#2016-24

Matt's Car Wash – Preliminary/Final PUD, SUP, PUD Amendment and Variations

Project Review for Planning and Zoning Commission

SHEET TITLE
Landscape Plan

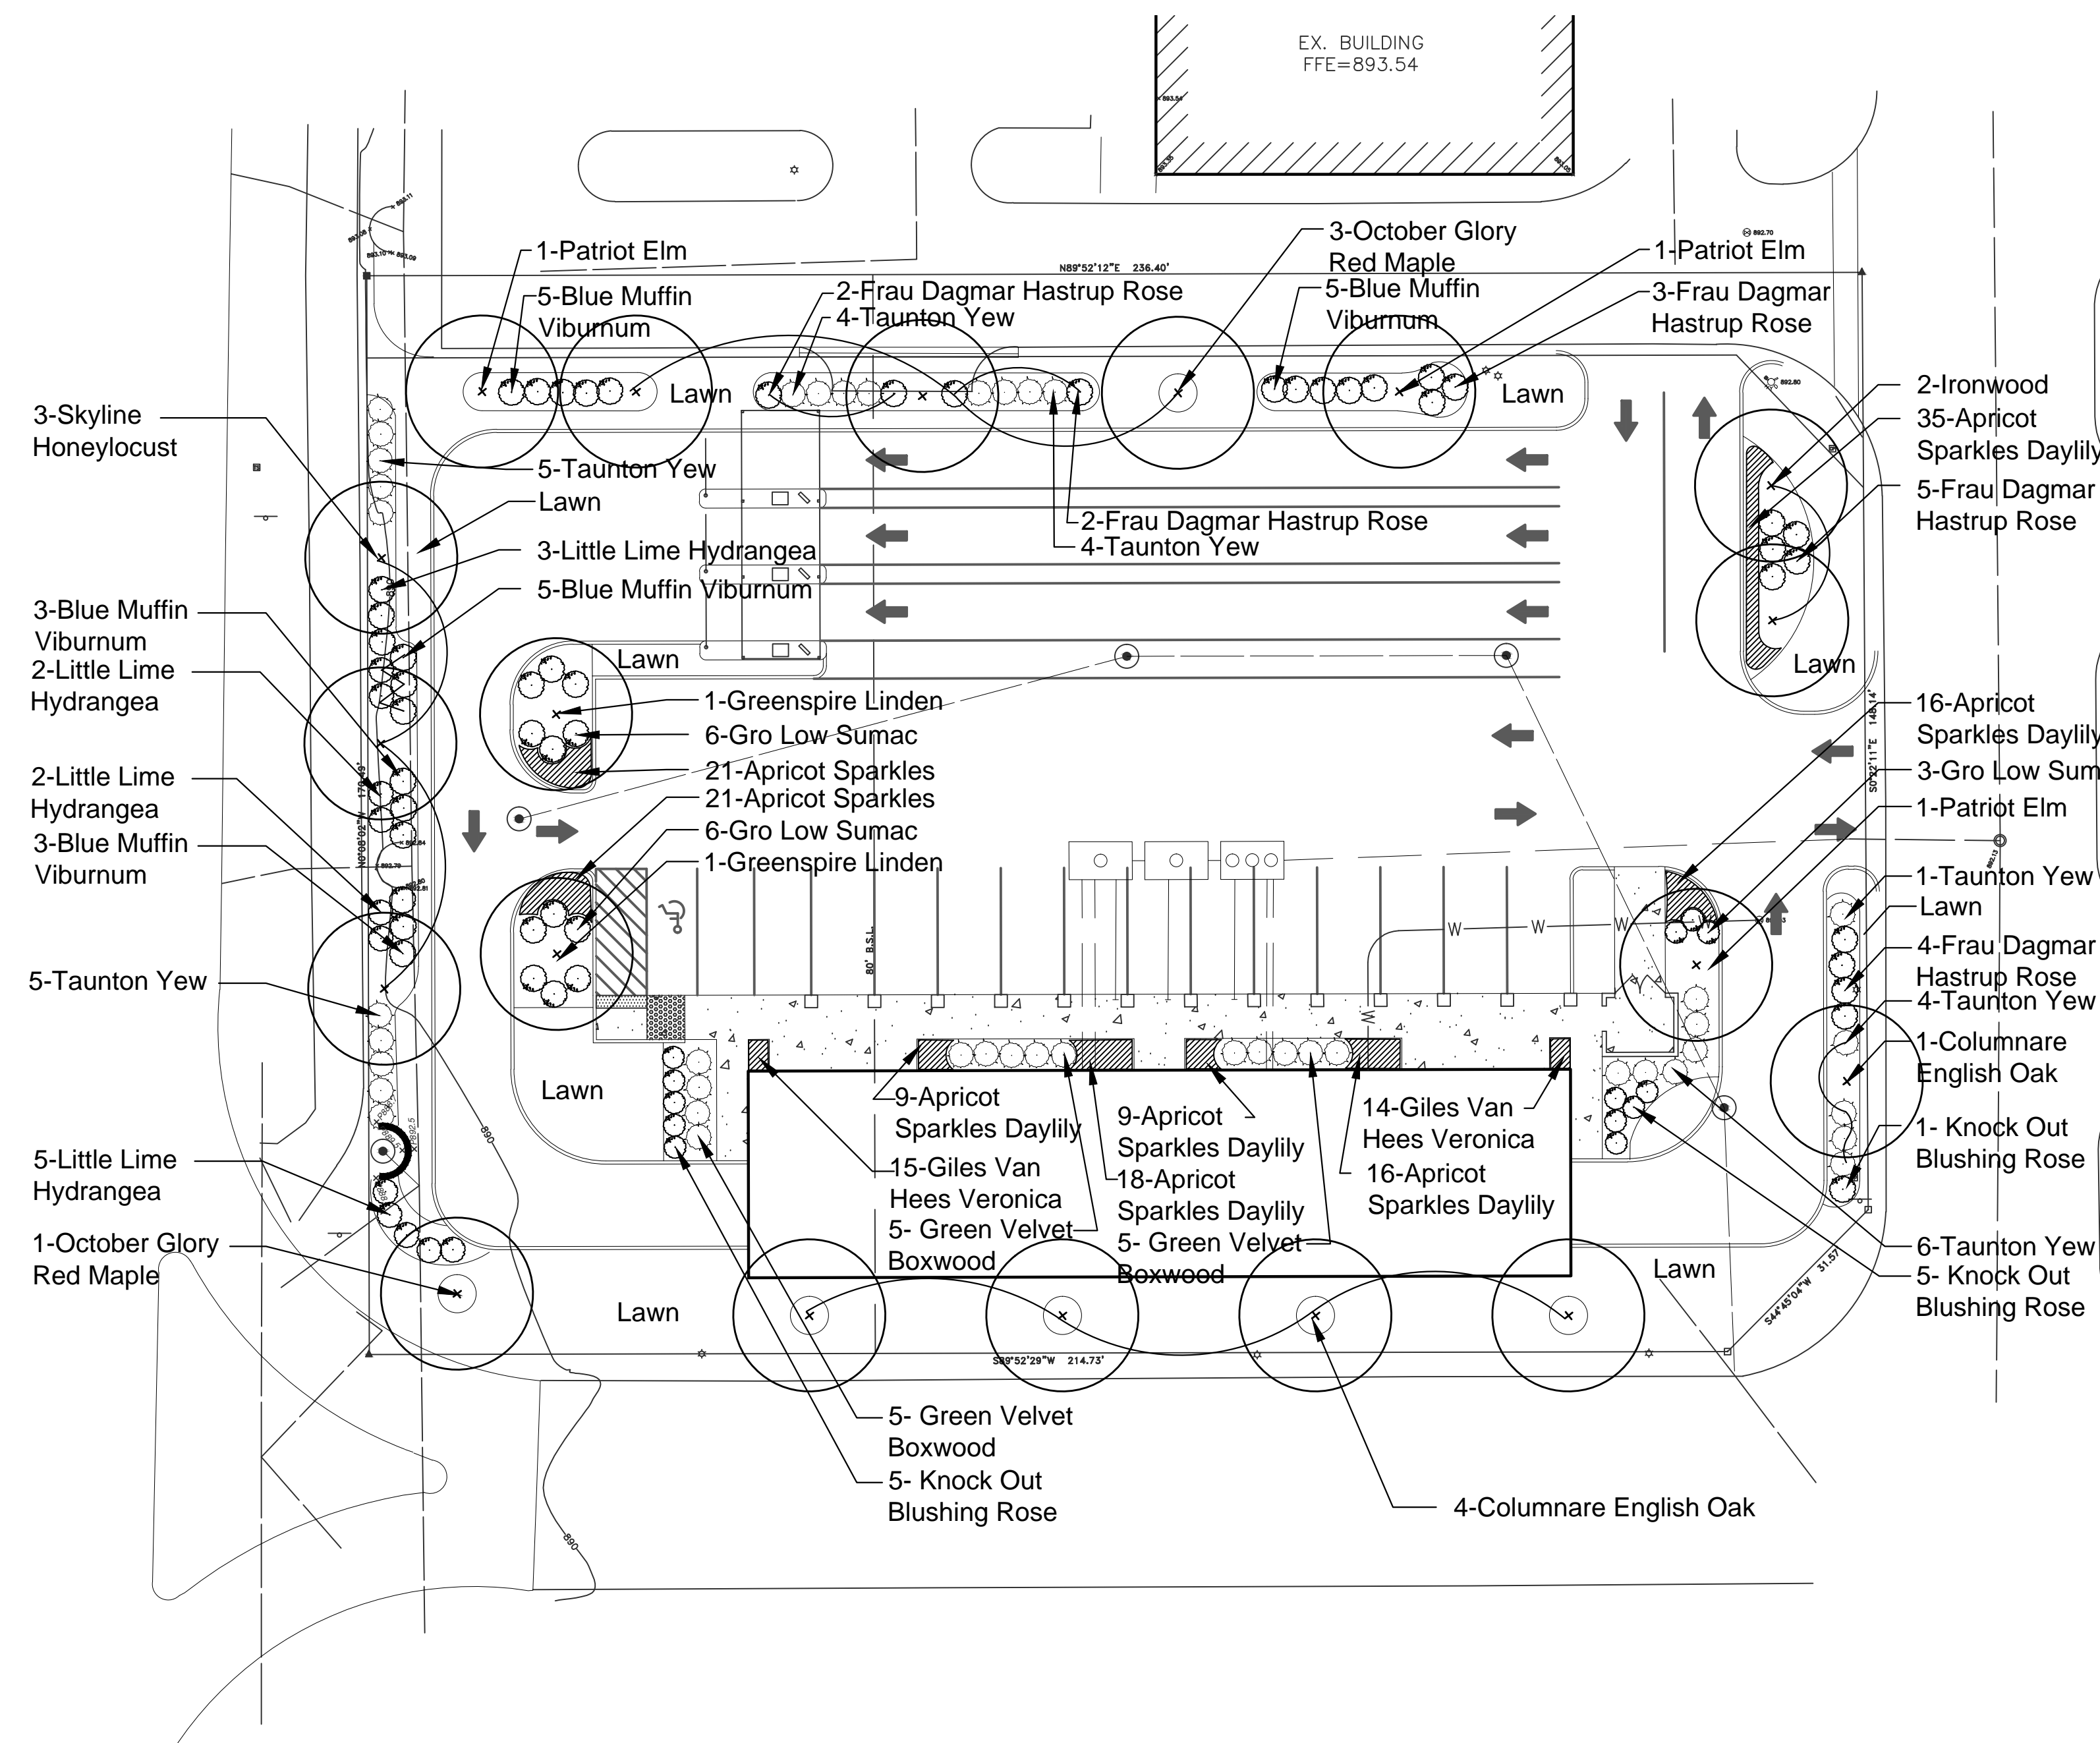
- The petitioner has provided a landscape plan illustrating trees, shrubs and flowers around the perimeter of the site.
- There is a good mix of small shrub material to provide screening from headlights to Route 31. Smaller shrubs and flowers are planted around the building.
- Additional shrubs, flowers and ground cover are required to meet the foundation base landscape requirements around the entire building.
- Additional landscape is required around the free-standing sign.

4. Landscape:
 - A. Add foundation base landscape around the entire building, only areas with the direct perpendicular sidewalk connection to a door are exempt.

- B. Landscape is required around the free-standing sign at 1 square foot per square foot of signage.
5. Signs:
 - A. Reduce the size of the signs to meet the requirements of the UDO including not more than 75 square feet per one elevation and not more than 150 square feet in total wall signage.

1 ONE (1) D.F. LED ILLUM. MONUMENT DISPLAY 3/8" = 1'-0"
 CABINET, RETAINERS TO BE BLACK. WHITE LEXAN FACES W/ DIGITAL PRINT
 AND BLUE VINYL GRAPHICS. FAUX STONE BASE TO MATCH EXISTING BUILDING.

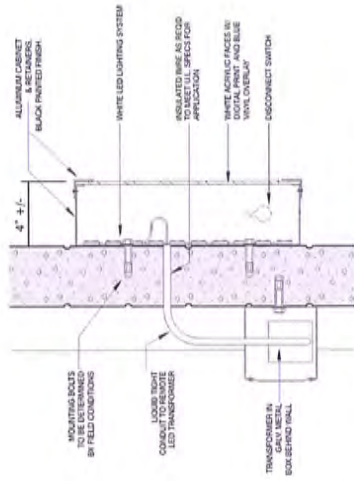
- A 60 square foot free-standing sign is requested for this site.
- Wall signage totals 153.7 square feet. 150 square feet of wall signage is permitted.

NORTH ELEVATION

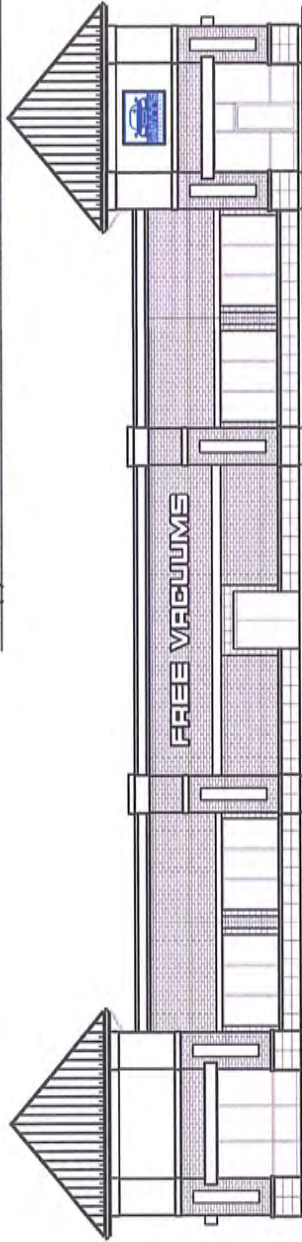
- On the north elevation there is 88.8 square feet of signage proposed. There is a maximum of 75 square feet of signage per elevation.
- There are three 8-foot-high 15-square-foot drive-through signs proposed.
- A condition has been added to reduce the signage to comply with the UDO.

The second variation is from Article 4-1000 F to allow 88.8 square feet of signage on the north elevation and a total of 153.7 square feet of wall signage. Staff would recommend they meet the UDO requirements for all signage.
